Office Action Summary

10/560,677

DETAILED ACTION

Fig. 2

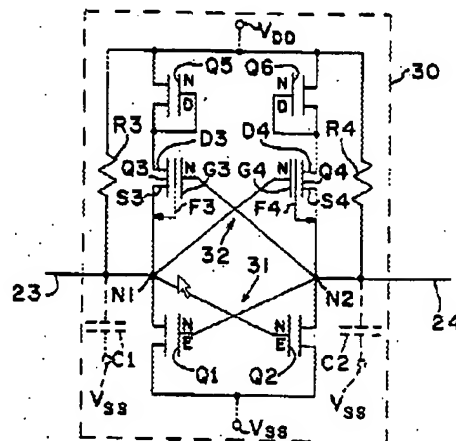
3. ***Regarding Independent claim 1***, Keshtbod teaches a static memory (**Fig. 2, Q1, Q2**) defining at least first and second nodes (**Fig. 2, N1, N2**) communicatively connected with read and/or write data lines (**Fig. 2, #23, #24**); at least one non-volatile memory (**Fig. 2, Q3, Q4**) associated with the static memory (**Fig. 2, Q1, Q2**), and writing data stored therein to the static memory (**Fig. 2, Q1, Q2**); the non-volatile memory (**Fig. 2, Q3, Q4**) comprising a first non-volatile element (**Fig. 2, Q3**) having a control gate connected to a first node (**Fig. 2, N2**) and a source connected to a second node (**Fig. 2, N1**), and a second non-volatile element (**Fig. 2, Q4**) having a control gate connected to the second node (**Fig. 2, N1**) and a source connected to the first node (**Fig. 2, N2**), the drain of each non-volatile element (**Fig. 2, Q3, Q4**) being connected by of a respective transistor (**Fig. 2, Q5, Q6**) to a supply voltage; characterized in that the respective transistors (**Fig. 2, Q5, Q6**) are arranged to isolate

the drains (**Fig. 2 D3, D4**) of the first and second non-volatile elements from the supply during a program cycle of the memory device (**Fig. 2, #30**).

4. **Regarding claim 2**, Keshtbod teaches the non-volatile memory elements (**Fig. 2, Q3, Q4**) comprise embedded flash or EEPROM elements (**Abstract, lines 3-5**).
5. **Regarding claim 3**, Keshtbod teaches the non-volatile memory elements (**Fig. 2, Q3, Q4**) comprise double or single poly floating gate type memory cells (**Abstract, lines 3-5**).
6. **Regarding claim 4**, Keshtbod teaches the non-volatile memory elements (**Fig. 2, Q3, Q4**) comprise devices, which can be programmed and erased by of tunneling of charges (**column 4, lines 58-61**).
7. **Regarding claim 5**, Keshtbod teaches the non-volatile memory elements (**Fig. 2, Q3, Q4**) are programmed with opposite data (**column 7 lines 1-3, 13-15**).
8. **Regarding claim 7**, Keshtbod teaches one or more respective selection

14. **Regarding claim 6**, Keshtbod teaches the static memory (**Fig. 2, Q1, Q2**)

Keshtbod is silent with respect to the static memory (**Fig. 2, Q1, Q2**) comprises a pair of cross-coupled inverters.

The examiner takes **OFFICAL NOTICE** that cross-coupled transistors is functionally equivalent to cross-coupled inverter. Either of the cross-coupled static memory design is very common practice in the industrial world. However the cross-coupled transistors design would provide smaller size for the memory chip, since cross-coupled transistors only used four transistors per memory cell.
